## 6C Containment Debris Protection for ECCS Strainers

The information in this appendix of the reference ABWR DCD is subject to several changes due to the adoption of a complex ECCS strainer design (e.g. Cassette Type Strainer). Consequently, for clarity it is presented in its entirety with the following departures incorporated. This strainer design has been used at numerous BWRs in Japan and numerous PWRs in the United States. The strainer is described in this appendix. Departure STD DEP Vendor changes General Electric (GE) to Toshiba in Section 6C.1.

STD DEP 6C-1 (Figure 6C-1)

Figure 6C-1 Cassette Strainer Cutaway

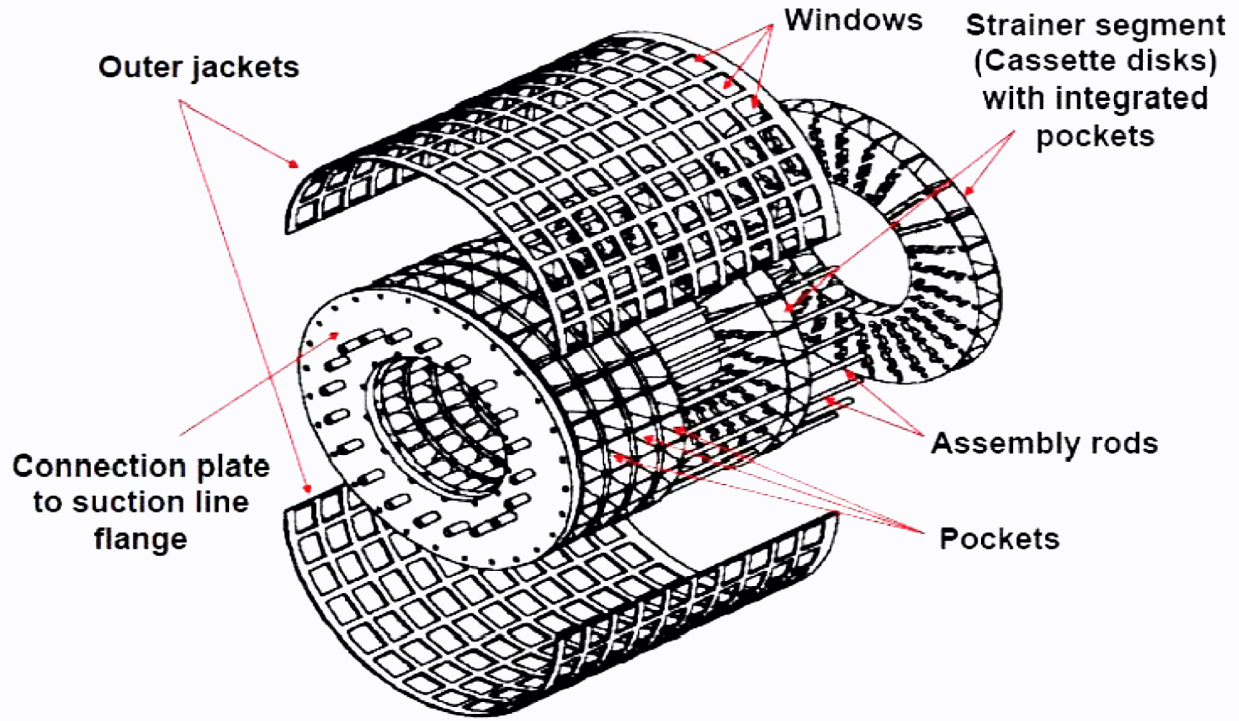
The suction strainers design at Perry preceded and did not meet the current regulatory requirements. The ABWR ECCS suction strainers will utilize a "T" arrangement with conical strainers on the 2 free legs of the "T" a cassette type strainer design. This design separates the strainers so that it minimizes the potential for a contiguous mass to block the flow to an ECCS pump. The design of the strainers will be based on Regulatory Guide 1.82, NUREG/CR-6224 (Reference 6C-4), NUREG/CR-6808 (Reference 6C-5) and the Utility Resolution Guidance, NEDO-32686-A. The cassette type strainer design is based on a set of cassette modules with U-shaped filter pockets attached to the cylindrical outer jacket. Each strainer consists of filter modules, the outer jacket and flange plates on each end of the cylindrical assembly. The filter module is constructed with cassettes which are arranged axially along the strainer axis. One cassette consists of pocket shaped filters which are arranged radially. A cut-away drawing of the strainer is shown in Figure 6C-1. The material used in the cassette type strainer is stainless steel. The cylindrical strainer assemblies are mounted in pairs on piping tees at each ECCS pump suction line. When the ECCS pump operates, the suction flow in the suppression pool runs into all pockets through the outer jacket windows. Each pocket has five flow paths from the inlet through the five perforated walls to the outlet of the pocket towards the cassette strainer. By using the cassettes with the pocket shaped filters, the strainer has an available filter area which is larger per volume than cylindrical and other shaped strainers. The number of cassettes and pockets is adjusted to produce a specific head loss performance for the strainer. To avoid debris clogging the flow restrictions downstream of the strainers, the size of the holes in the perforated sheets is chosen by considering specific flow paths of ECCS equipment and piping (for example, the containment spray nozzle and the ECCS pump seal cooling flow orifices). The strainers will have holes no larger than 2.1 mm.

- (6) ~~(5)~~ *The equipment installed in the drywell and wetwell minimize the potential for generation of debris.*
- (7) ~~The ECCS suction strainers~~ *The cassette-type ECCS strainers meet the current regulatory requirements unlike the strainers at the incident plants.*
